CITY OF SEQUIM
STAFF REPORT
 GRUBB SHORT PLAT
 PLANNING FILE SHP 22-001
NOTICE OF DECISION: OCTOBER 28, 2022

Grubb Preliminary Minor Subdivision
SHP-22-001 Staff Report

FIGURE 2
PRELIMINARY PLAT LAYOUT

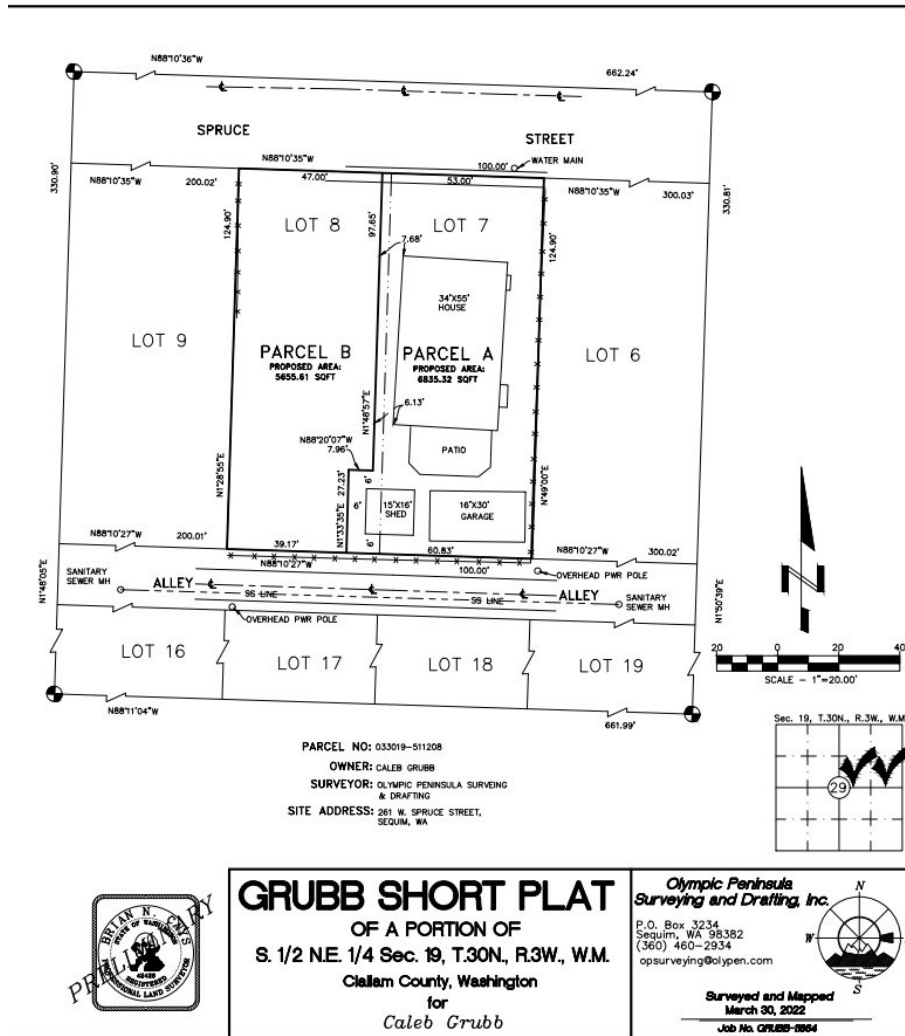
The property is currently developed with a single-family residence with a detached garage and accessory shed that are located along the east half of the property. All structures are located on what would be proposed as Lot A.

Staff discussion: The property is currently developed with a single-family residence with a detached garage and accessory shed that are located along the east half of the property. All structures are located on what would be proposed as Lot A. The detached structures are subject to SMC 18.59. Per SMC 18.59.020(A)(5), Maximum Structure Width. The combined width as measured parallel to the rear property line of all detached accessory structures over 10 feet in elevation shall not exceed 40 percent of the lot width. The combined width of the two detached structures is 46’ and the proposed new width of the lot is 60.83’ meaning that this would become a non-conforming use. The approval of a short plat can not result in the creation of a non-conformity; therefore, prior to final short plat approval, the existing accessory structures must be removed or modified to satisfy the code.

2. Prior to final short plat approval, the pre-existing detached accessory structures must be removed or modified in order to come into compliance with SMC 18.59.
